## DEPARTMENT OF TRANSPORTATION

### Federal Aviation Administration

[Docket No. FAA-2006-25773; Directorate Identifier 2006-SW-16-AD; Amendment 39-14758; AD 2006-19-01]

#### **Airworthiness Directives; Eurocopter Model AS350B, B1, B2, B3, BA, D, and AS355E Helicopters**

**Figure 1**

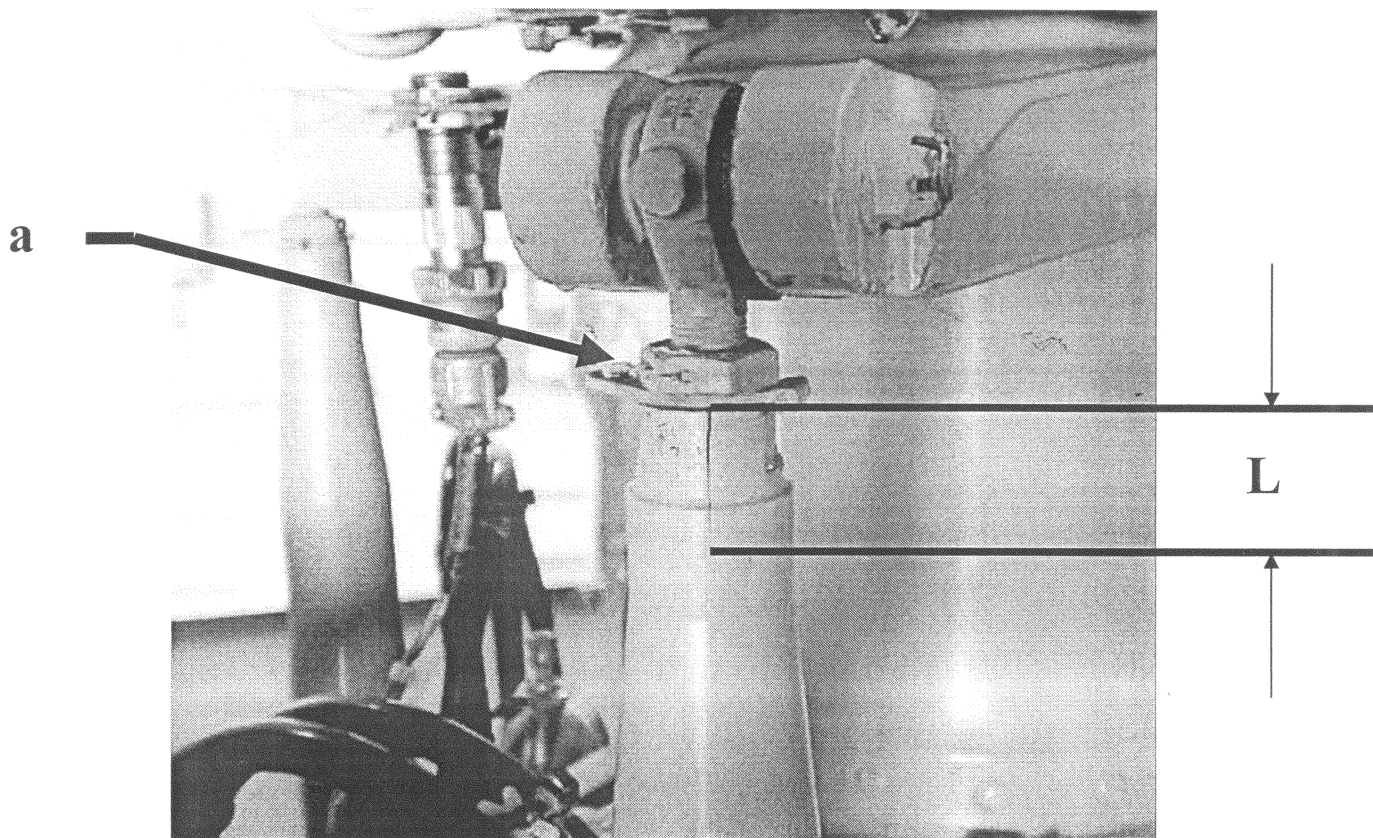
(3) Loosen attachment nut “a” shown in Figure 1 of this AD and lift the positioning lock washer under the attachment nut so the edge below the lock washer at the top of the tapered housing is visible around the entire periphery.

(4) Visually inspect each MSC tapered housing for a crack using a 10-power or higher magnifying glass paying particular attention to area “L” and to the edge of the tapered housing located under the lock washer under attachment nut “a” as depicted in Figure 1 of this AD.

(1) Adjust the tightening torque on the attachment nut that secures the upper ball end of the MSC to between 177–199 in-lbs (2–2.25 decanewton meters (daN·m)).
